HESS-2015-512-Discussions

Modeling glacial lake outburst flood process chain: the case of Lake Palcacocha and Huaraz, Peru
M. A. Somos-Valenzuela, R. E. Chisolm, D. S. Rivas, C. Portocarrero, and D. C. McKinney

RESPONSE TO THE COMMENTS OF REVIEWER 1

Figure 1 (Figure 11 in revised paper). Maps published by INDECI (2003) indicating the extension of past mudflow events with the large avalanche scenario superimposed on top of them.

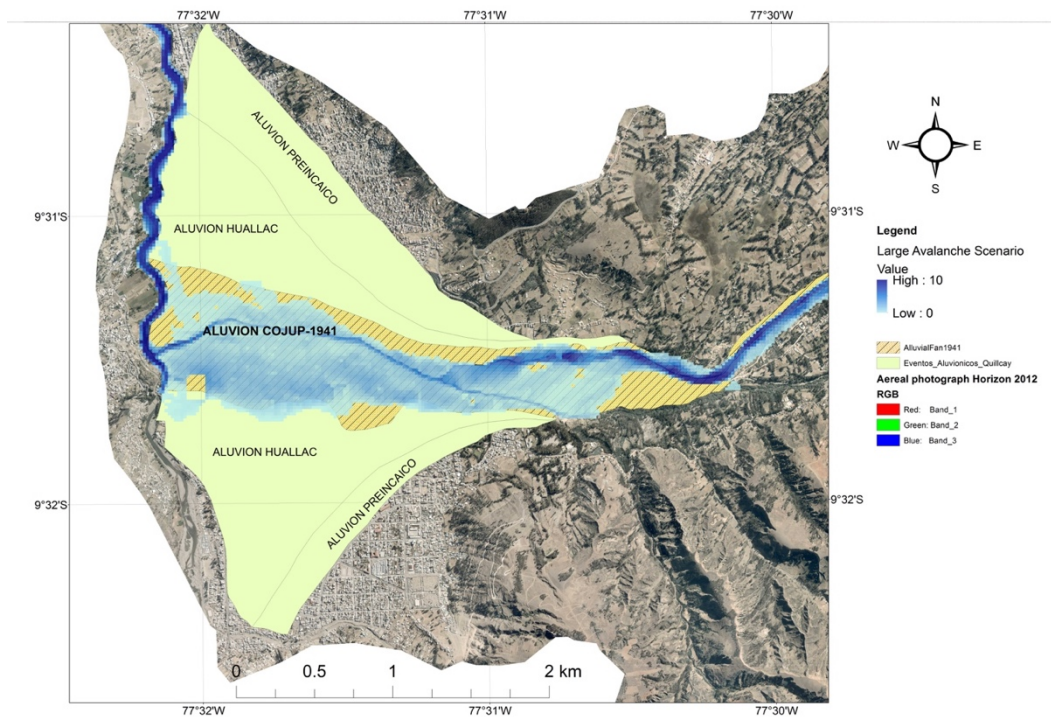
Use of past events to calibrate the models: there was a GLOF in 1941 from the same lake which unfortunately has never been studied in any reasonable detail so far. The breaching process at the lake was different than what today could happen because the moraine at that time was intact. So not of much use for the lake overtopping/dam breach process but there is probably interesting information out there regarding flood propagation and flood levels and flow characteristics down to Huaraz. I'm definitely not asking for a detailed study and comparison of this historical case, this would be way beyond the scope of this paper (also considering that the paper already is quite packed). However, I think the authors should make reference to this event and the potential to compare or calibrate the flood models applied. I recently visited the area and there are some flood deposits visible in the flow channel (in the Cojup valley) which may be used to calculate discharge per cross-section. Or they may want to use the historical photographs available to compare their inundation areas with the historical case (at least in a qualitative sense).

We agree with the reviewer that a study of the GLOF event from 1941 would add a lot of information for this work and similar works elsewhere. Although the reviewer pointed out correctly that such effort is out of the scope of this particular manuscript, it is important to mention the authors attempt in 2012 to carry out such studies in the area with the help of the Mountain Institute in Huaraz, the Ministry of Environment of Peru and the support of the Interamerican Development Bank. Our goal then was to generate a high resolution DEM, study the GLOF from 1941, the stability of the moraine and the debris that a potential GLOF could pick up on its way to Huaraz. Unfortunately all of this could not be completed and we were only able to finance the generation of the DEM which is used in this study. Additionally, the 1941 event changed the topography, so it is not completely analogous to the potential event we are modeling (Rivas et al., 2015). The qualitative comparison described in the next paragraphs has been added to the end of the Discussion section of the revised paper.

New text: “There are still many unknowns about the 1941 event, including the precise lake volume at that time, underlying bathymetry and pre-GLOF moraine morphology, flood volume and discharge hydrograph; aerial images and derived historical maps represent the only sources of information, known to the authors, about the physical characteristics of the 1941 GLOF, providing at least a rough visual estimation of the flood area. In a qualitative comparison with the GLOF from 1941, we used a map published by the Instituto Nacional de Defensa Civil (INDECI, 2003) where three mudflow event extensions are delineated: Aluvion Preincaico, Aluvion Huallac and Aluvion Cojup 1941. In Figure 1 (Figure 11 in revised paper) we plot the inundation extension reported in this paper on the map of the 1941 event delineated by INDECI (2003) and confirm that the inundation modeled has reasonable dimensions in comparison with this historical information. The volume at the time was estimated to be on the order of 14 million m^3 (Vilimek et al., 2005), which is more than 7 times the volume that we have calculated for the large avalanche (1.8 million m^3). This may explain the fact that in our results the inundation does not pass out of the bank from the Cojup River to the Quilcaihuanca River in the area where the rivers are very close together near the entrance to the eastern border of the city. However, these results demand caution; a qualitative comparison only describes potential differences between simulated and observed flood areas. Because the moraine failure in 1941 changed the upstream conditions at Lake Palcacocha, historical aerial images of flooded areas constitute no source of information for precise calibration for our model.”

9 **Figure 5. Zones of comparison to validate using BASEMENT for wave-driven breach models.**
 10 The length of each zone is conceptual and not precise. The locations of the upstream boundary
 11 and the target cross section coincide with equivalent flux surfaces in FLOW3D.

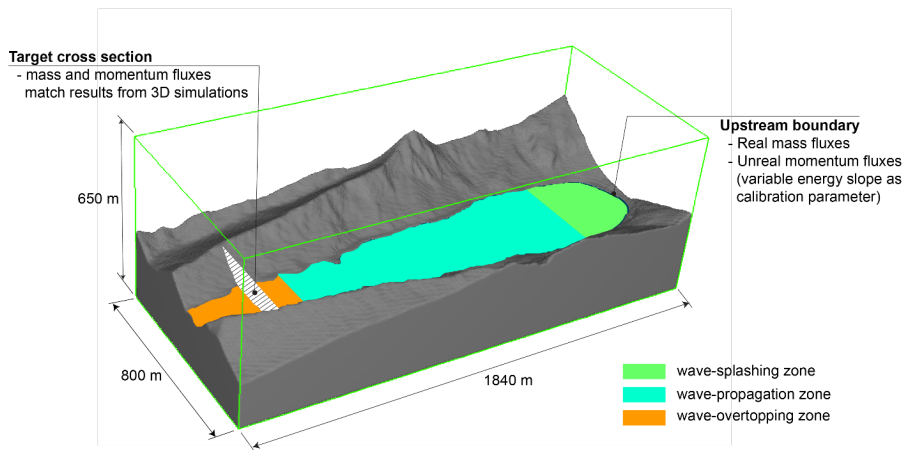
Comment [DCM26]: Response to Specific Comment 9

26 The BASEMENT model was started in the zone of the lake where wave generation occurs (wave
27 splash zone in Figure 5), but the method of simulating wave generation was different from that
28 used in FLOW3D because the flow characteristics at the inflow boundary must be artificially
29 altered to compensate for the additional energy loss in the 2D shallow water equation (SWE)
30 representation of BASEMENT. To facilitate comparison between the FLOW3D and
31 BASEMENT models, hydrographs of results were compared at a common cross-section for both

1 models, located at the crest of the terminal moraine (target cross-section in Figure 5). Adjusting
2 the slope of the energy grade line at the upstream boundary (Figure 5) allowed an iterative
3 increase in momentum inflow until mass and momentum fluxes over the crest of the moraine
4 (target cross-section) matched the results from the FLOW3D simulations.

Figure 7. Flood hydrographs at 5 cross-sections downstream of Lake Palcacocha for the large avalanche and current lake level scenario. Inset shows results on a larger vertical scale for cross-sections 2-5.

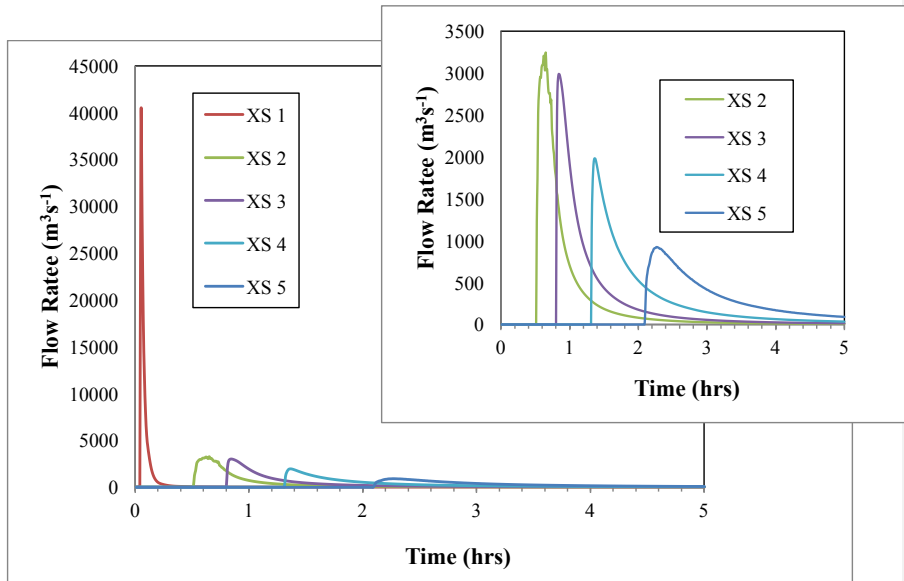
p. 27, l. 1-6: I would be good to also show the arrival times for the small/medium scenarios (cf also Fig. 7).

We agree with this comment and we include the small and medium scenarios in Table 6. Now the text of Page 26 line 25 after the “.” reads:

Figure 11. Maps published by INDECI (2003) indicating the extension of past mudflow events with the large avalanche scenario superimposed on top of them.

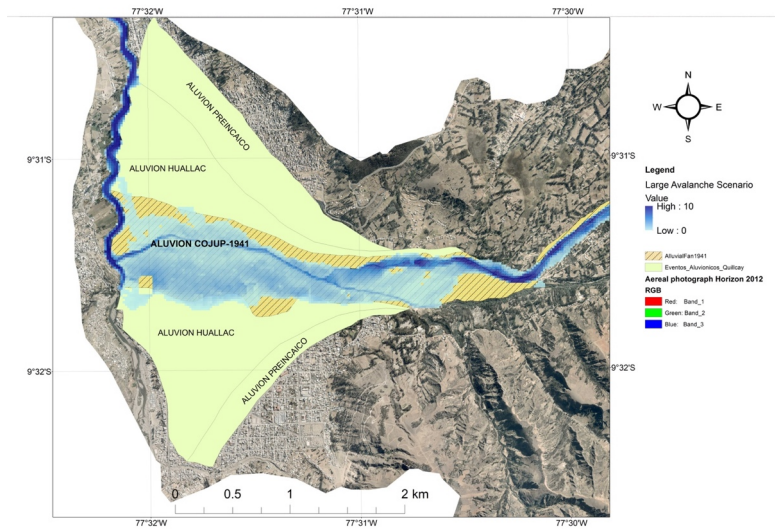
Comment [DCM27]: Response to Reviewer 1, General Comment 1
